This TSB applies to 2009 Audi TT, A3 and A4 models, equipped with the 2.0L TFSI engine. Timing chain noise may be heard, accompanied by DTC P001600.

The check valve (A) and bearing bridge (B) of the camshaft positioner bridge

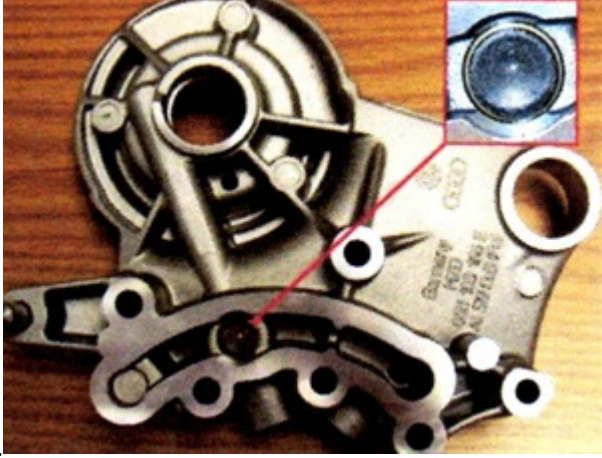
The check valve ball in the camshaft positioner bridge may become dislodged. Fragments of the screen and the ball can restrict oil flow to the bearing bridge. Particles of the screen can also reach the camshafts and damage the bearing surfaces.

An optimized oil check valve in the camshaft positioner bridge has been used as of calendar week 23/2009.

1. Check the non-return valve in the bearing bridge for wear.
2. Check the chain tensioner.
3. Check the camshaft surfaces for damage.

If the screen and check valve are not damaged, replace the camshaft and bridge, and erase the DTC.

If the screen or check valve are damaged, inspect the bearing surfaces of the camshafts for scoring marks, and replace any camshaft or cylinder head that exhibits camshaft bearing damage.
